MEMORANDUM

Subject: RZN 17-0006 – Request to rezone the Old Blacksburg Middle School property at 501 South Main Street from R-4 Low Density Residential to Downtown Commercial (DC) and Planned Residential (PR) zoning districts by Steve Semones (agent) or behalf of Midtown Development Partners LLC (applicant/owners).

SHEET NO.
Z4
 JOB NO. B1200098.00

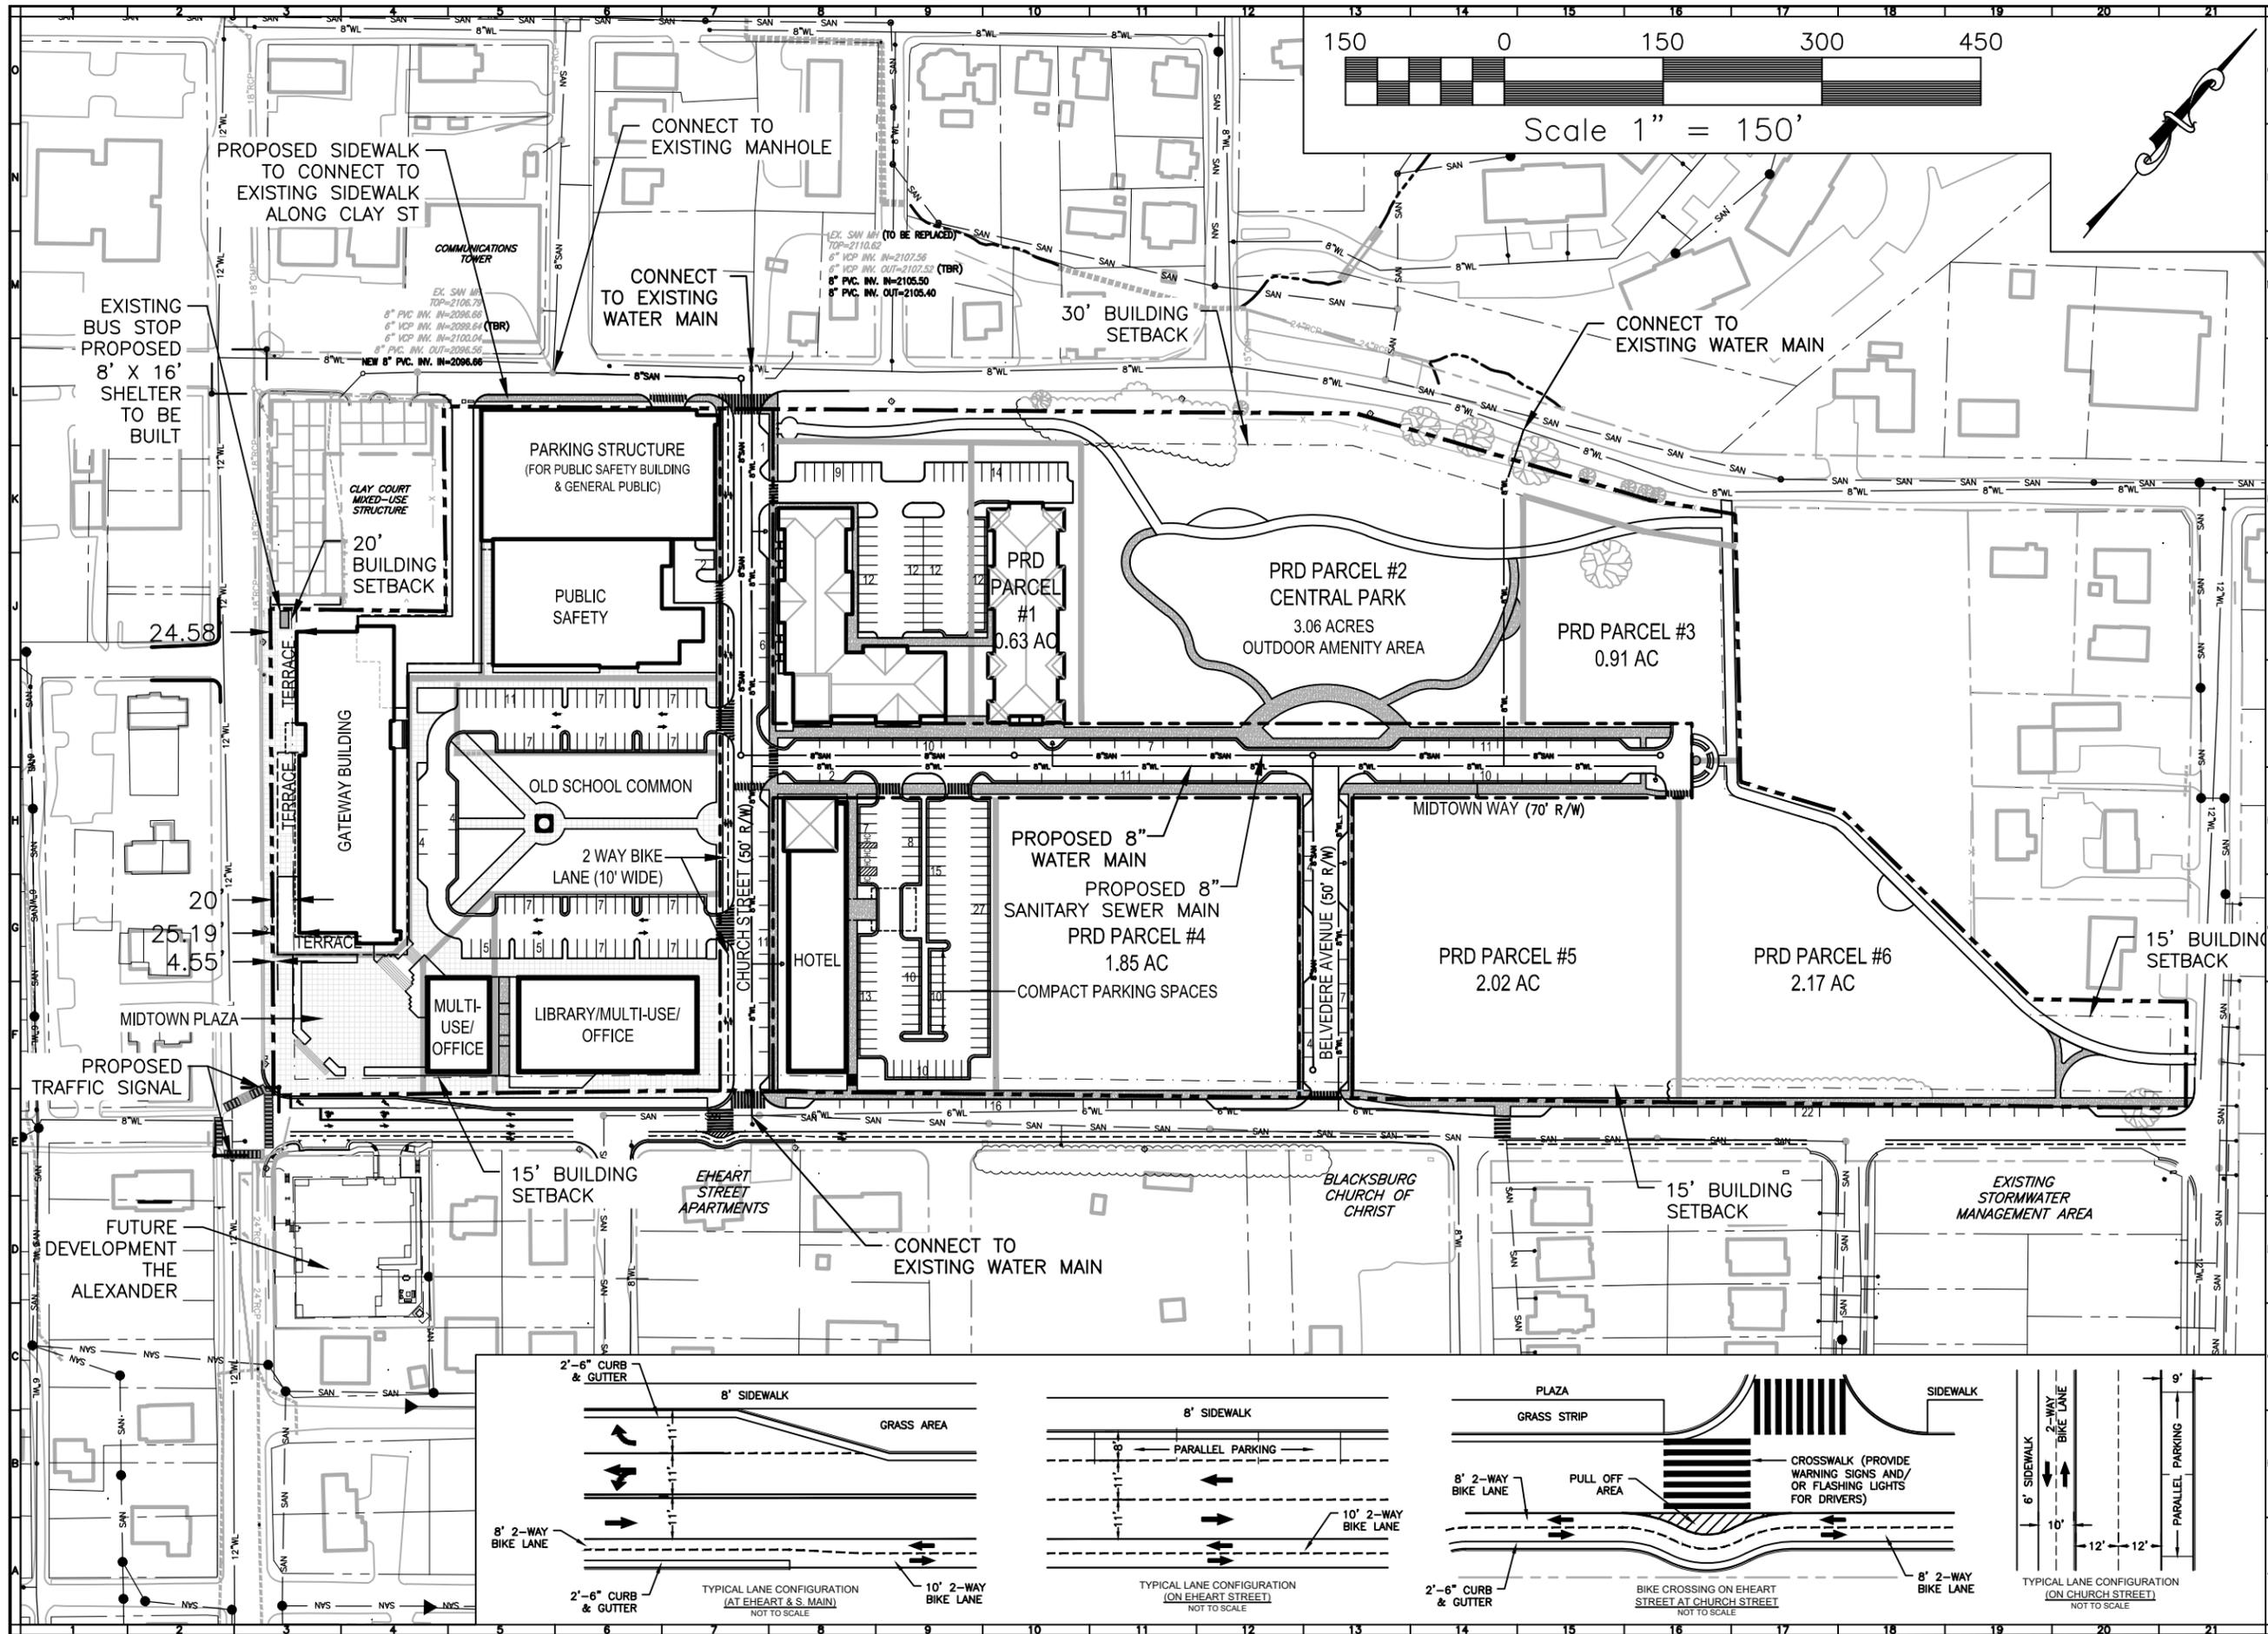
- The Applicant met with the Fire Code Official to go over emergency access for the development. The Applicant has revised the application making adjustments to PR Parcel #3 to provide a minimum of 20’ for access on the eastern side of the building. The access requirement is shown on Sheet Z4. This appears to satisfy the concerns regarding emergency access.

- The Applicant was originally working with staff to design two-way cycle tracks for both Eheart Street and New Church Street. The Applicant submitted the attached layout (Z4 dated 4/13/18) showing two-way cycle tracks are feasible for both streets. After further review, cycle tracks are most beneficial on streets with few conflicts with driveways and side streets and where the cycle track can be implemented continuously. In addition to these factors, the difficulty of safe transition areas at the intersection of Church Street and Clay Street led to a revised staff recommendation for bicycle lanes on New Church Street as opposed to a cycle track. The revised submission dated August 10, 2018 includes bicycle lanes on either side of Church Street. This submission currently does not show the previously discussed two-way cycle track which is still the recommended and agreed upon treatment for Eheart Street. The revised application materials show the bike lanes on New Church Street. The graphic attached to this memo shows the cycle track on Eheart St.
